No. EC155-31-026

SERVICE BULLETIN

INDICATING AND RECORDING SYSTEMS - VEMD and CAD VEMD and CAD obsolescence

Related to modification 0731C05

Figure 1

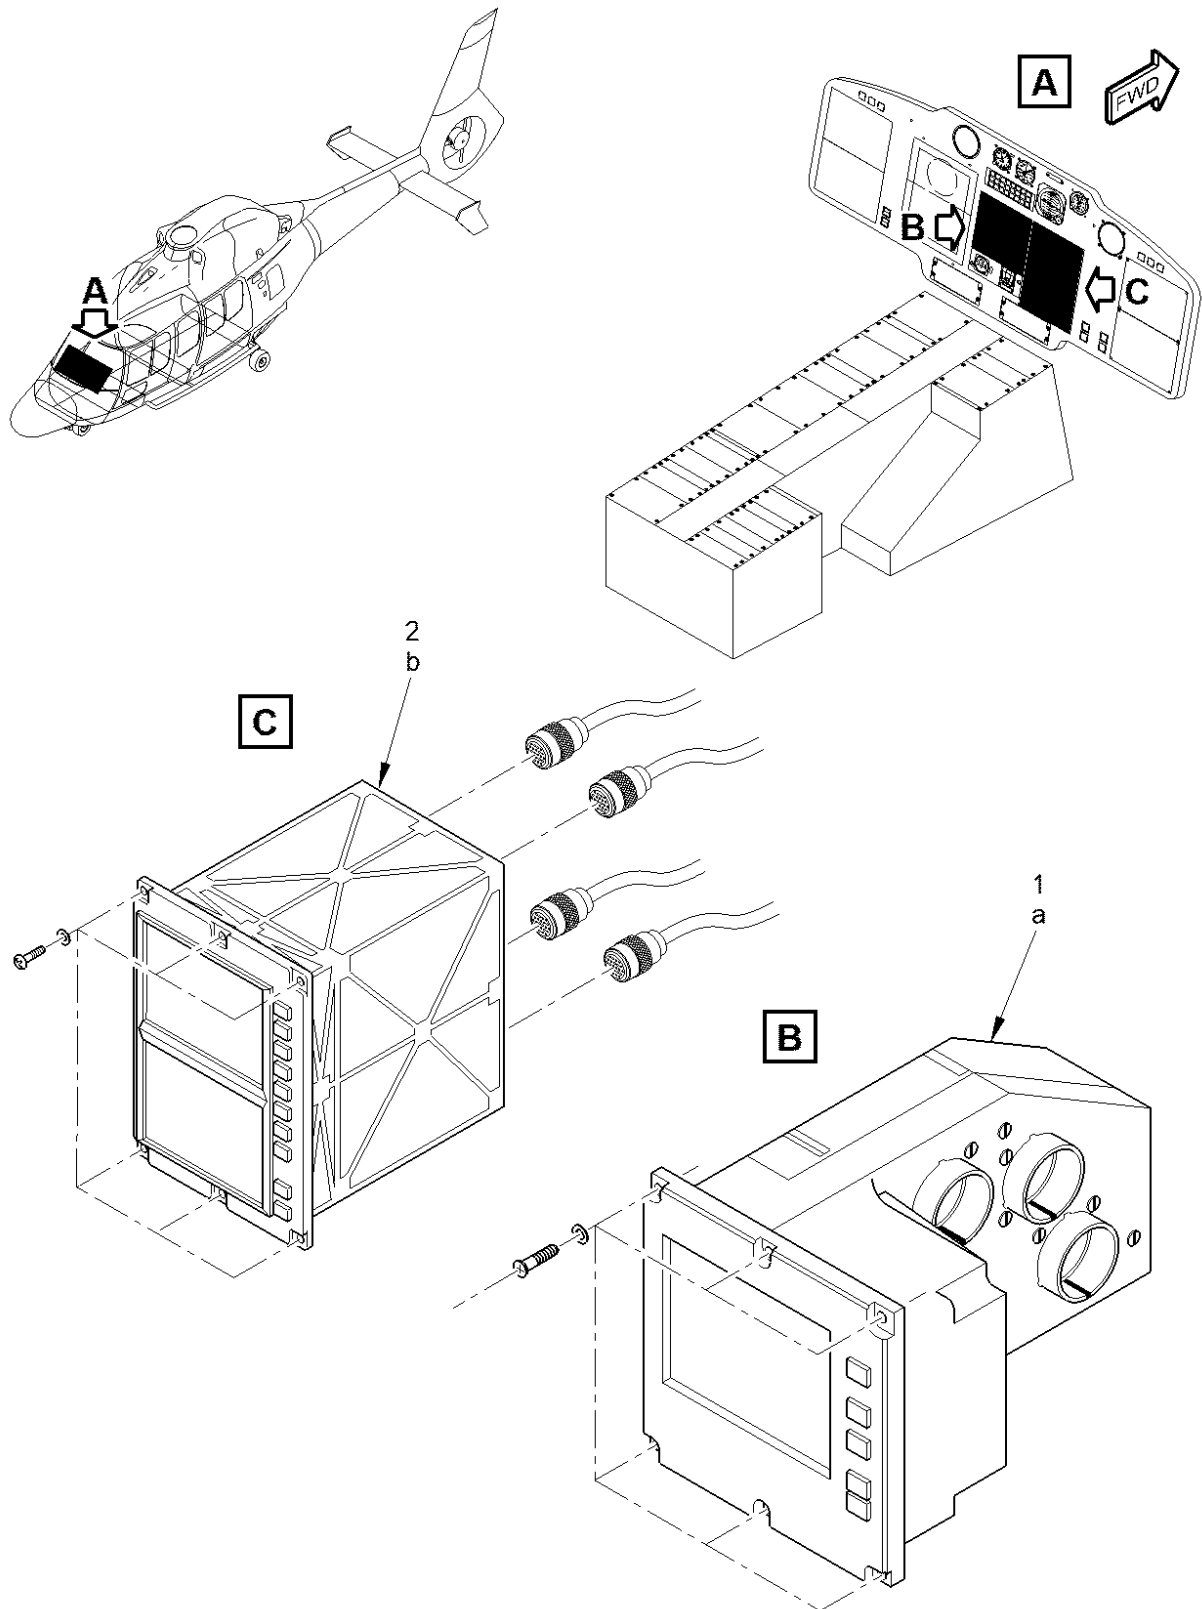
Before you remove the equipment items, do a check of the PRE MOD reference of the CAD (a) and the VEMD (b). Refer to paragraph [2.C.](#)

- Remove the VEMD (b) and the CAD (a). Refer to Task 31-60-01-061 (AMM) and Task 31-51-01-061 (AMM).
- Send back the VEMD (b) and the CAD (a). Refer to paragraph [2.D.](#)
- Make sure that the VEMD (2) and the CAD (1) references sent back by the manufacturer are correct. Refer to paragraph [2.C.](#)
- Install the VEMD (2) and the CAD (1). Refer to Task 31-60-01-061 (AMM) and Task 31-51-01-061 (AMM).
